PERMIT AND BID SET FOR:

BEAR CLAW II BUILDING REMODEL

No.	Description	Date
1	ADDENDUM 01	2018-11-30
2	Plan Review Comments	2019-04-26

1 A101 02 FIRST LEVEL - REMODEL (PORTE COCHERE)
1/4" = 1'-0"

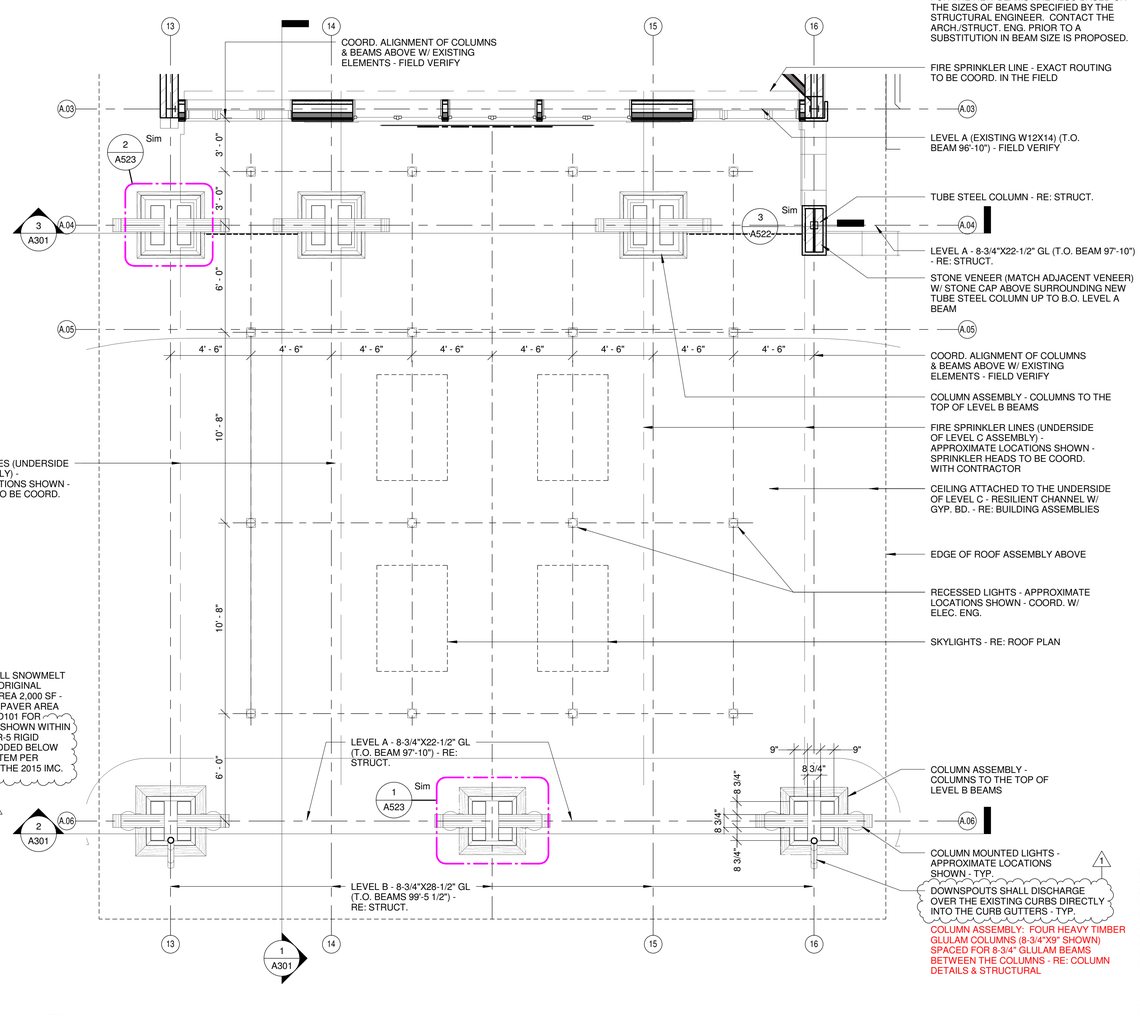
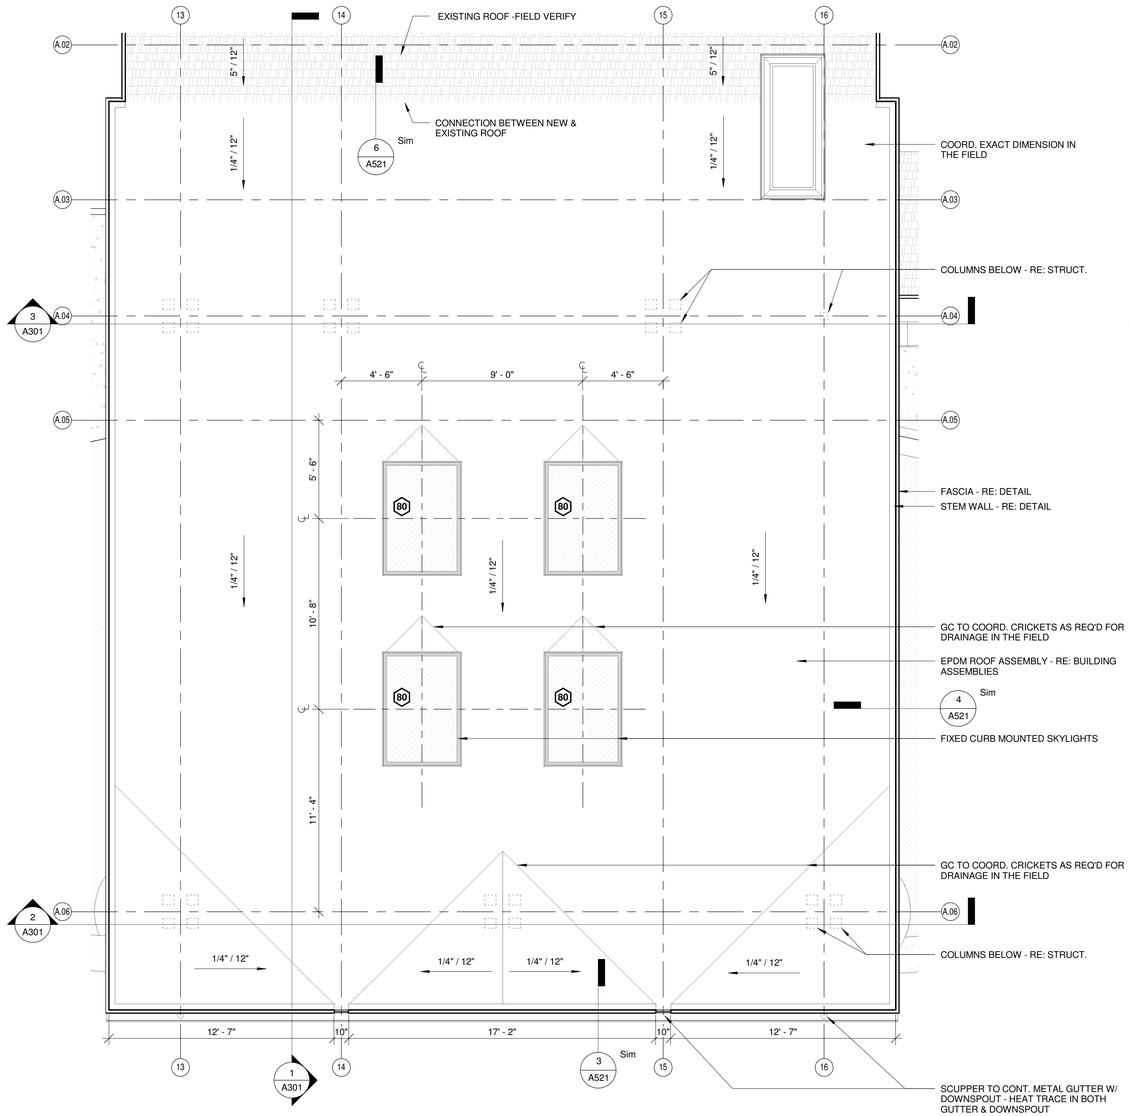
8. Sheet A101: The entry drive area under the Porte Cochere will have all the pavers removed and a new snowmelt system installed in this area, on sheet A101 you reference sheet AD101 for the entire layout of the snowmelt system, however this sheet does not show the layout or insulation being installed. A minimum of R-5 insulation will be required per the 2015 IMC Section 1209.5.1 below the hydronic piping throughout all areas where the snow melt system will be exposed or added within the Porte Cochere area, and other areas mentioned in the narrative on Sheet A000 including "Add Alternate" scope of work as well.

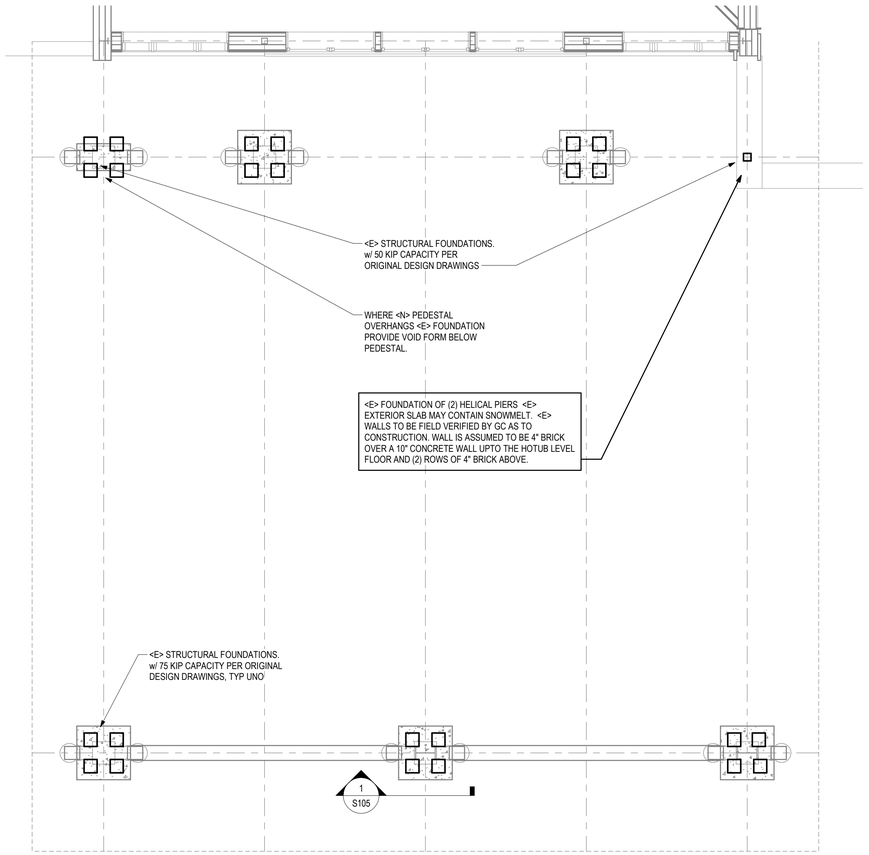
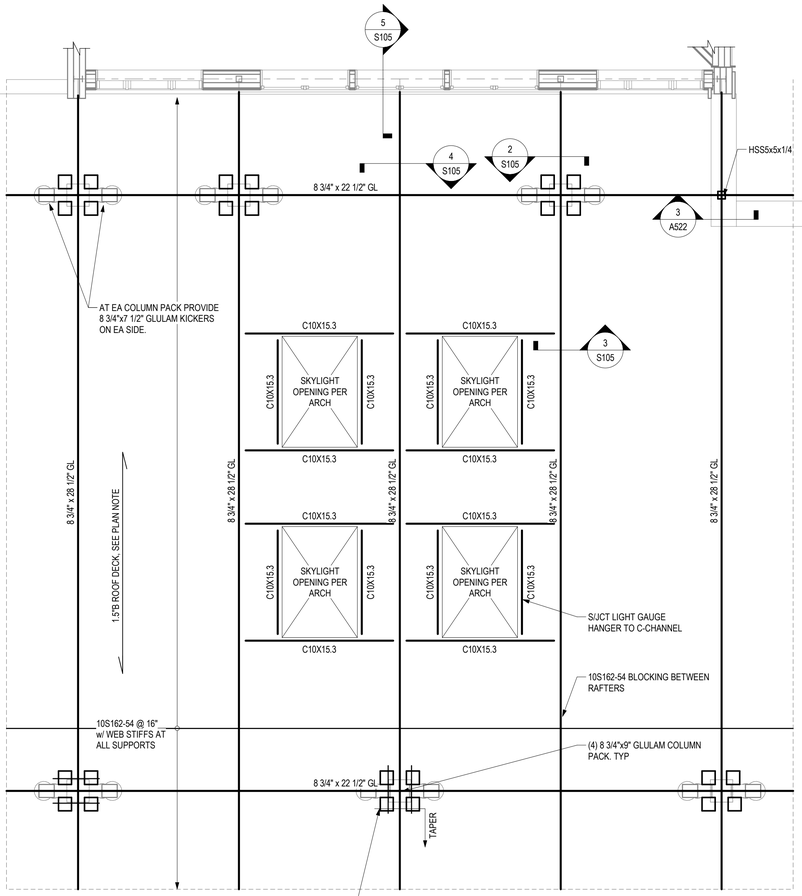
2. Sheet S001: The provided Ground Snow Load value under Roof Live Loads is shown as 88PSF, RCRBD has a Ground Snow Load Value of 116PSF for this location. Please clarify how the roof construction was designed and what Ground Snow Load values were used to derive the Roof Snow Load values. Your Flat Roof Snow Load is listed as 125PSF (prescriptive)
